Nov. 2022

Leimac Ltd.
LED Lighting Group
Sales Department
TEL: +81-77-585-6771
FAX: +81-77-585-6773

Notice of Specification Change for Output Control Cable (IC-MCS2-* Series)

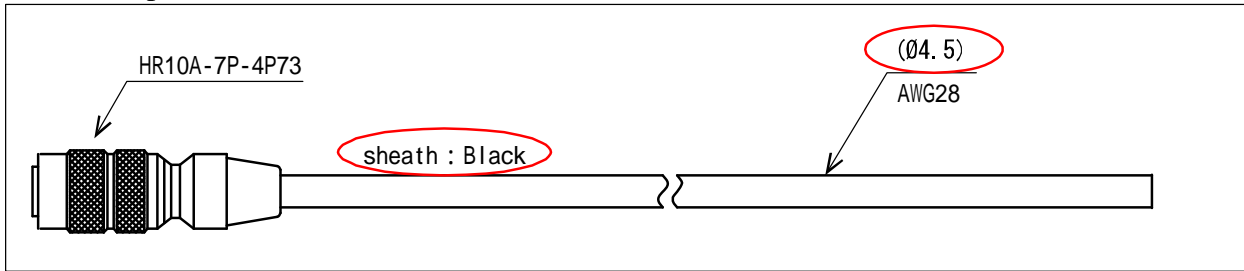
Due to the specification change, "-C01" is added to the end of the model number for the new specification product.

Current specification		New specification
IC-MCS2- -		IC-MCS2- - -C01

【Appearance of the product】

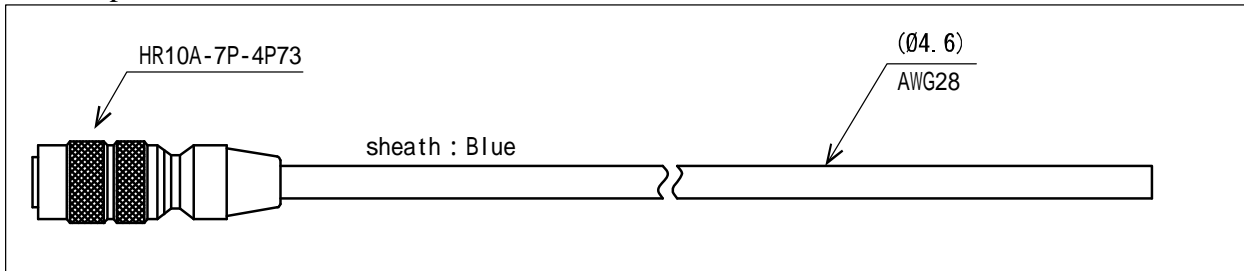
Change in cable components

Current specification	New specification
Outer Diameter	φ4.6	φ4.5
Sheath Color	Blue	Black

* No change in pin assignments and wiring colors
